ZONING AND PLATTING COMMISSION
SITE PLAN REQUEST FOR REVIEW AND COMMENT

CASE NUMBER: SP-2014-0181D **ZAP DATE:** 01/20/2015

PROJECT NAME: 901 River Road (Fill & Shoreline Modifications)

SP-2014-0181D Site
Existing slip to be filled

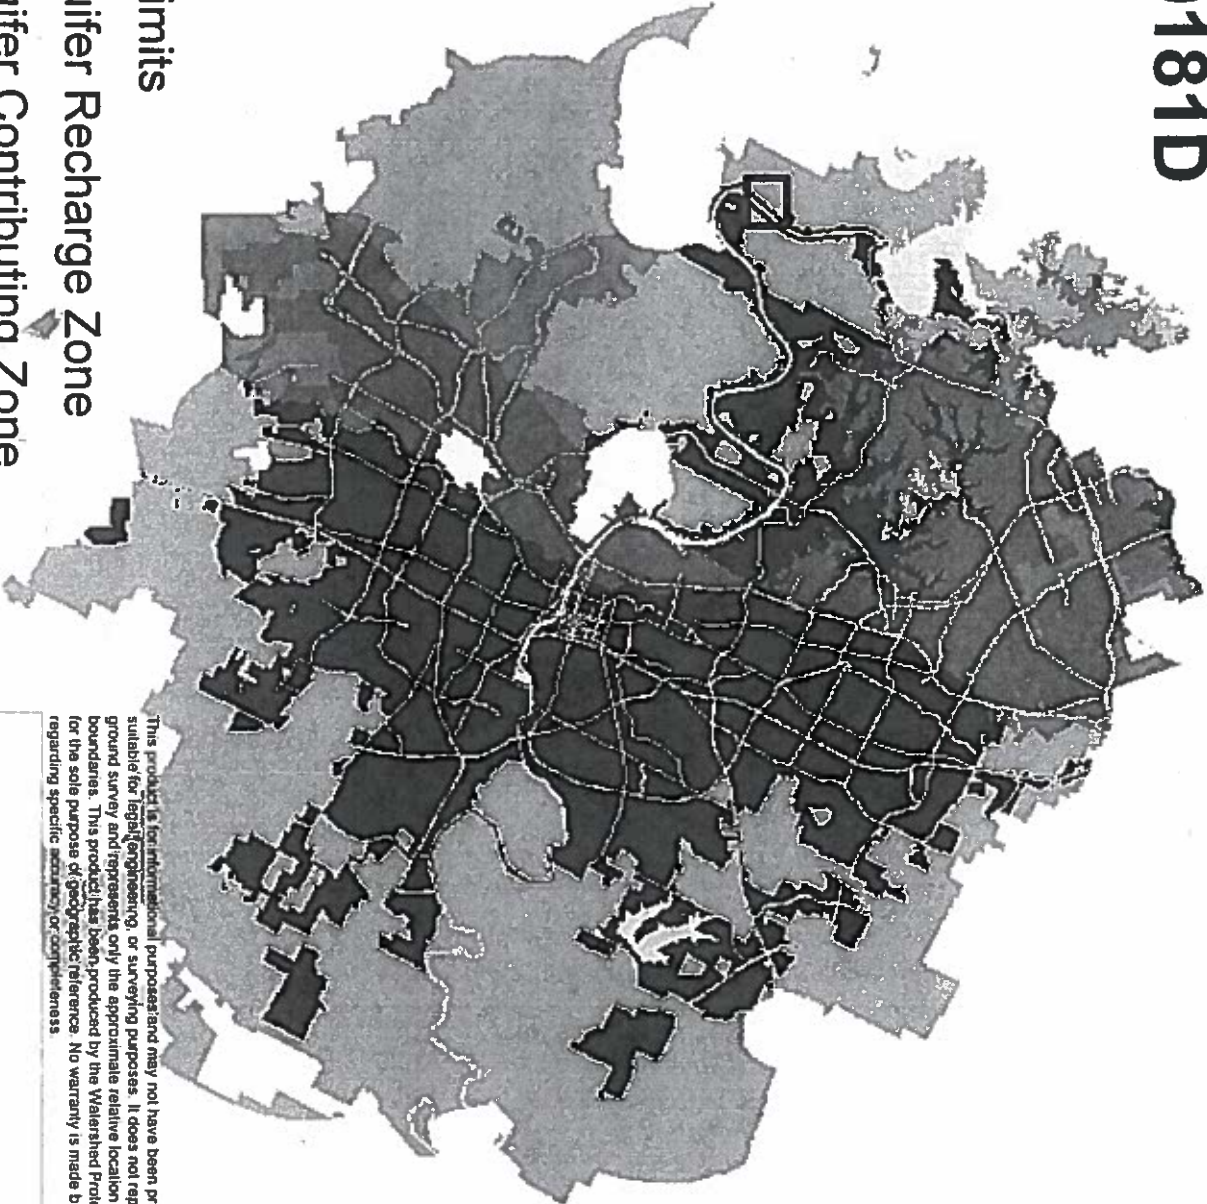
- Multiple single family lots combined into one (Lots 1-5 Horseshoe Bend Estates).
- Shoreline consists of existing bulkhead with an existing cut-in slip.
- Applicant proposes only to build a new wide dock and associated stairs.
- Proposed floodplain modification is code-compliant. The riparian function of the shoreline will be improved. No CWQZ variance required.

Existing cut-in slip
